Re: TUM-24-1446

The Notice of Application for, Vista Views at Black Lake – TUM-24-1446 is ready to view (see attached). If you have any questions or would like additional information, please contact Alex Baruch at 360-754-4180 or abaruch@ci.tumwater.wa.us.

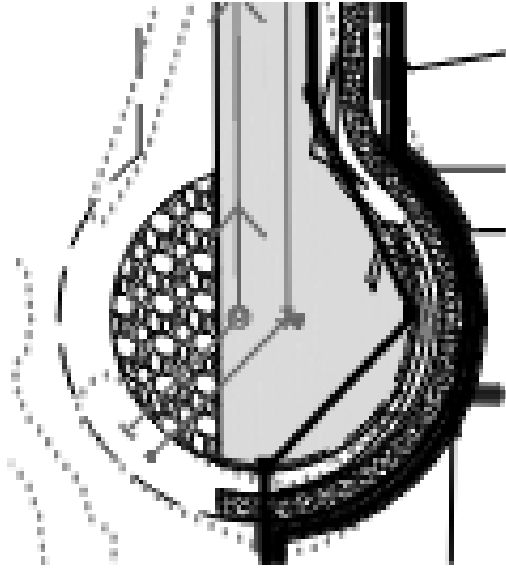
3. What are the currently proposed provisions for city sewer and water? I believe the current plan is to route the city sewer and water on 58th Ln SW, we request the sewer and water to go all the way to the cul-de-sac at the end of 58th Ln SW. As owner of the 3.67-acre lot (Parcel 12705210104) on the south side of 58th Ln we request stub out provisions to be included to the south side of the paved surface of 58th Ln SW for future possible subdivision for this parcel without late comer's fees.

- Water and sewer are proposed to be extended through the cul-de-sac and stub-outs are shown on the preliminary infrastructure drawings.

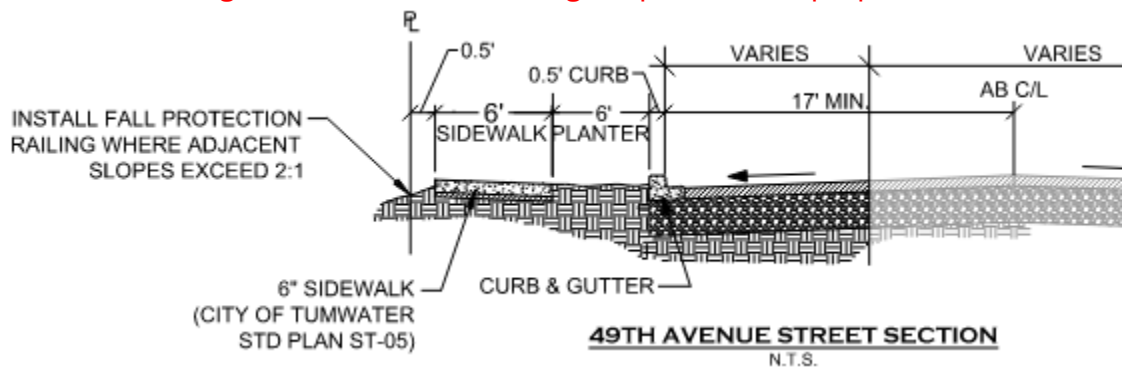
- Along the north side of 58th Lane the current plan shows a six foot parking lane.
 - Please see the diagram below for the frontage improvements proposed for 49th Ave.
